Staff Report

Agenda Date: June 3, 2025
Agenda Item: Variance Request 13532 Valley Vista Drive Building B

Project Description: Variances to regulations of the Unified Development Code pertaining to Master UDC Section 3.5.3.12- Storefront Code; Transparency.

BUILDING B - TRANSPARENCY EXHIBIT

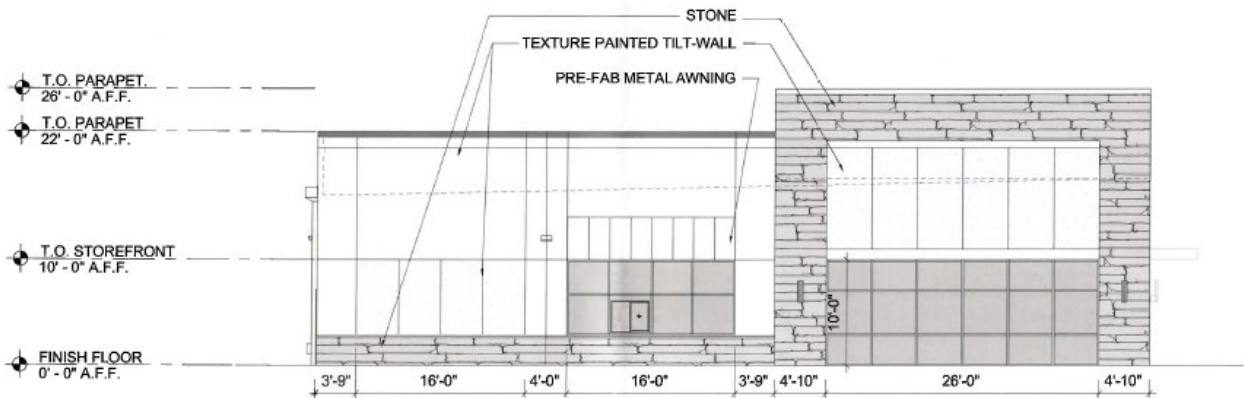
In regards to the variance request at 13532 Valley Vista Road - Building B , we are requesting to have the transparency requirement of sixty-five (65%) as required by the UDC Section 3.5.3.12 Storefronts reduced to from sixty-five (65%) to fifty - three (53%).

Exterior Wall Area: 79 LF
Transparency Required: 65% = 51 LF
Transparency Provided: 53% = 42 LF

- Windstorm area
- Cost associated with additional glazing, steel and material to meet the requirement.
- Kitchen behind glass

The purpose of this code is to ensure the security and welfare of the occupants which could be monitored from the street or right of way. Staff recommends that the city denies the variance and they maintain the 65% transparency to the Southside of the building to meet the intent of the Unified Development Code.
